This application has been prepared by Ethos Urban on behalf of Mirvac Projects Pty Ltd (Mircac), pursuant to section 96(1A) of the *Environmental Planning and Assessment Act 1979* (EP&A Act) to modify Development Consent SSD 7317 which relates to the development of a commercial campus at the Australian Technology Park, Eveleigh.

The purpose of this modification request is to seek approval for the placement of mechanical exhausts, flues, vents and photovoltaics on top of the roof of Building 1 and amend the wording of Condition A14 accordingly.

**Figure 1 - 9am Shadow Analysis**

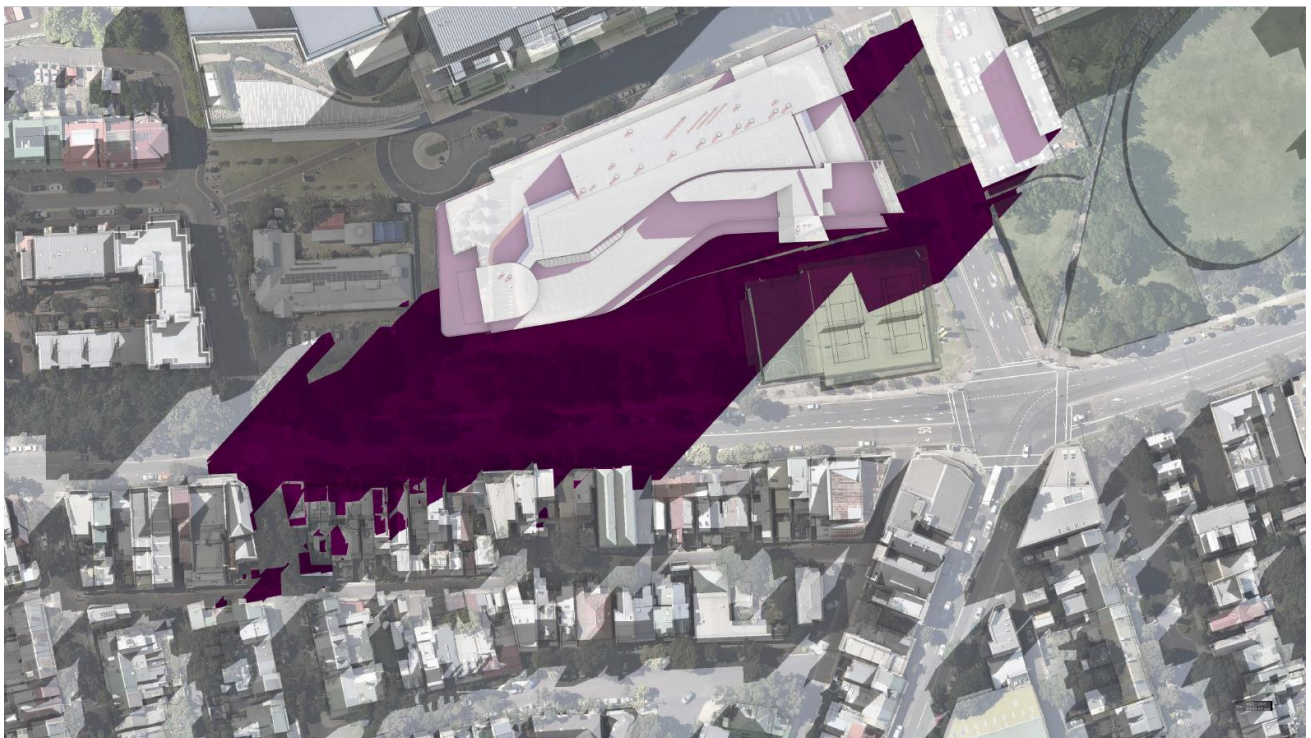
Given their proposed positioning and setback from the edge of the building, the proposed placement of mechanical exhausts, vents and photovoltaics on to the roof of Building 1 does not alter the approved built form of Building 1, and will not give rise to any additional overshadowing impacts or visual impacts. The acute angle presented by the increase in exhaust, vents and photovoltaics will be indiscernible from normal view angles at ground level.

Specifically, any shadows cast by the proposed elements will be over the roof of the building itself and does not increase the area of overshadowing cast over neighbouring properties.
